Access Compliance Report

Public Rights-of-Way

(Curb Ramps)

Intersection ID: 11349	Main Street: N_DAVIDSON_ST	Cross Street: PARKWOOD_AV	Location: E
ADA ID: 023A7ED207C2	Ramp Type: Perp	Initial Pass/Fail: Fail	Overall Compliance: No
Codes/Mitigation Info/Possible Solution		Field Measurements/Component Compliance	
Severity Score: 8.75

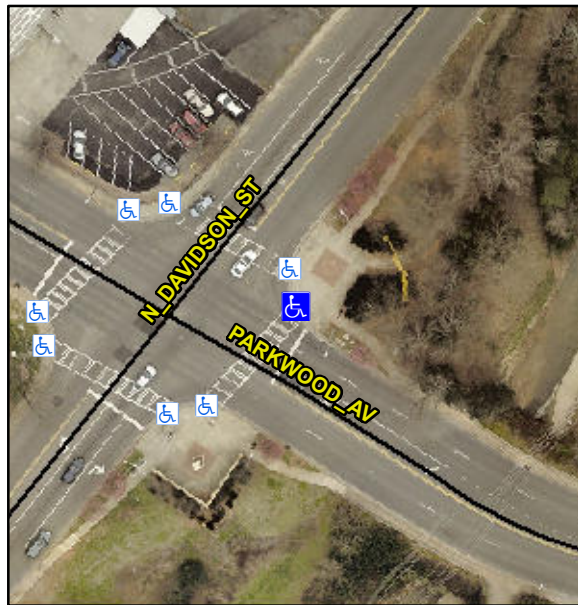
Not Found, R304.5.1

Compliance	Description	Data	Compliance	Description	Data
N/A	Ramp Length (in)	65.5	Yes	Ramp Slope (%)	5.1
No	Ramp Width (in)	46.5	Yes	Ramp XSlope (%)	0.4
N/A	Flare Type LT	N/A	N/A	Flare Type RT	N/A
N/A	Flare Slope LT (%)	N/A	N/A	Flare Slope RT (%)	N/A
N/A	Flare Traversable LT?	N/A	N/A	Flare Traversable RT?	N/A
N/A	Landing Length (in)	N/A	N/A	DWS Provided?	N/A
N/A	Landing Width (in)	N/A	N/A	DWS Contrast?	N/A
N/A	Landing Slope (%)	N/A	N/A	DWS Length (in)	N/A
N/A	Landing X Slope (%)	N/A	N/A	DWS Full Width?	N/A
N/A	Landing Curb? (Y/N)	N/A	N/A	DWS Offset (in)	N/A
N/A	Shared Landing?	N/A			
N/A	Gutter Ponding?	N/A	N/A	Gutter Slope (%)	N/A
N/A	Gutter Lip Ht (in)	N/A	N/A	Gutter X Slope (%)	N/A
N/A	Painted X Walk1?	Yes	N/A	Painted X Walk2?	N/A
	X Walk 1 Direction	To SW		X Walk 2 Direction	N/A
N/A	X Walk 1 Width (in)	111.0	N/A	X Walk 2 Width (in)	N/A
	X Walk 1 Slope (%)	1.4		X Walk 2 Slope (%)	N/A
	X Walk 1 X Slope (%)	0.5		X Walk 2 X Slope (%)	N/A

Remove & Replace Entire Ramp.
